SUBJECT: Service Instruction M20-88A - STABILIZER TRIM STOP/SCREW MODIFICATION
Dated 12/14/2016.

SERVICE INSTRUCTION M20-88A
Date: December 14, 2016

SUBJECT: STABILIZER TRIM STOP/SCREW MODIFICATION

INTRODUCTION: This Revision Supersedes M20-88 Dated 5/1/1990

Figure SI M20-88-1

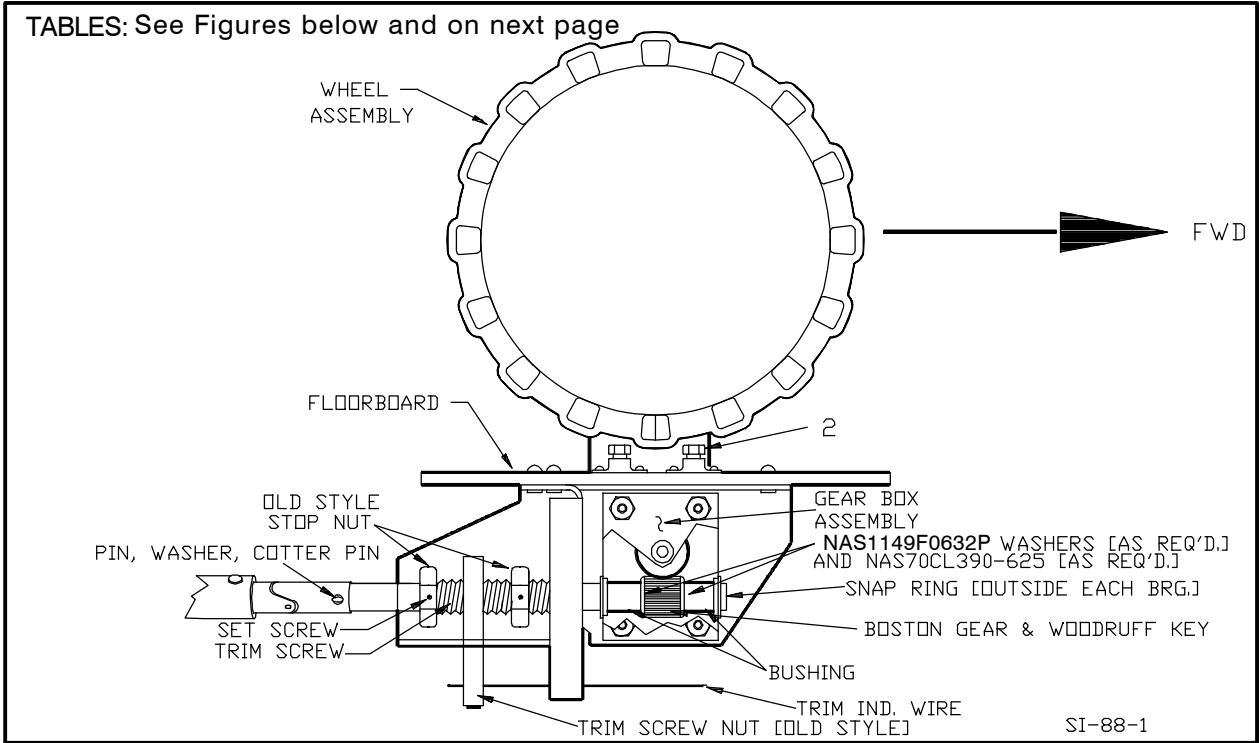
4. Remove cotter pin, washer and pin that secures trim tube universal joint to trim screw (Figure SI M20-88-1).
5. Loosen gear box bolts (Index 1, Figure SI M20-88-2) if not already done, and both NAS428-3-4 bolts (Index 2, Figure SI M20-88-2) to give slack in roller chain between upper and lower sprocket of trim control wheel assembly.

7. Remove roll pin, P/N RPA52-028-125-1125 holding lower sprocket, P/N 740049, to gear box shaft. Remove sprocket.
8. Loosen set screw, #6-32 x 1/8, in each existing trim stop so they will unscrew easily. Remove aft trim stop (DN stop) from trim screw (Fig. SI M20-88-1).

12. Measure and document longitudinal free play in trim screw shaft (end play) as assembled in the gear box assembly.
13. Remove forward snap ring from trim screw. Reference Figure SI M20-88-1
14. Lightly tap trim screw at forward end, with a plastic mallet, to drive trim screw, bushings, washers, gear and aft bearing from gear box assembly housing. Bearings are installed with loctite (Blue) at assembly, so some effort may be required to break it loose. **DO NOT DAMAGE BEARING OR HEATING THE HOUSING.**
15. When existing trim screw, and components attached to it, comes free from gear box housing, the bushings, washers, gears, woodruff key, snap ring and aft bearing will be removed. Retain components, except woodruff key, to place back on new trim screw (Fig. SI M20-88-1).

16. Install existing snap ring, P/N NAS51-37 on mid groove of new trim screw, P/N 740016-019. Re-assemble shim(s), bearing, bushing, washer(s), Boston gear, new woodruff key, washer(s) and spacer on new trim screw.

Figure SI M20-88-2

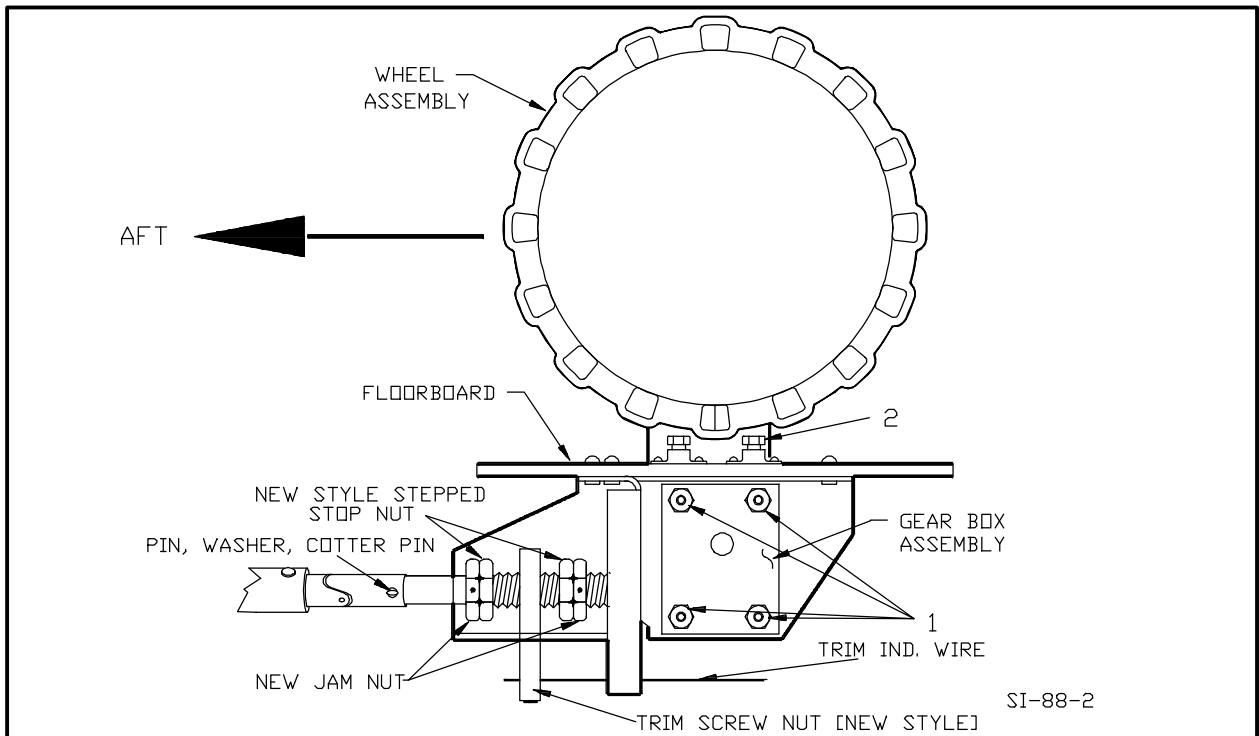
1. Remove belly access panels or smooth belly fairing to gain access to lower side of the trim control wheel assembly.
2. Remove trim indicator wire from trim screw nut by loosening set screw(s) that restrain trim wire.
3. Remove any brackets connected to gear box bolts (Index 1, Figure SI M20-88-2) both sides if required. Different models have different type of brackets.

22. Install one jam nut (UP stop side), P/N 740086-003 (M20J) or 740086-001 (M20K, M20L or M20M), on trim screw. Screw toward gear box housing leaving approximately 0.375 inch gap on threads between gear box and jam nut (Figure SI M20-88-2).
23. Install one stepped stop nut (UP stop), P/N 740086-007 (M20J) or 740086-005 (M20K, M20L or M20M) on trim screw. Screw toward gear box housing and against jam nut installed in step 22.

24. Position gear box/trim screw assembly to lower trim wheel assembly so new trim indicator nut, P/N 740086-011 (M20J) or 740086-009 (M20K, M20L or M20M) can be placed on trim screw and screwed in place to proper position within slotted bracket area. This is the reverse of Steps 9 & 10.
25. Install other stepped stop nut (DN stop) (stepped side toward trim indicator nut) on trim screw.
26. Install other jam nut on trim screw against stop nut (DN stop).
27. Reverse Steps 2 thru 7 to reposition gear box assembly back on trim wheel assembly. Do not tighten trim indicator wire set screw at this time. Position all other brackets but do not tighten bolts holding gear box assembly to trim wheel assembly (Fig. SI M20-88-2).
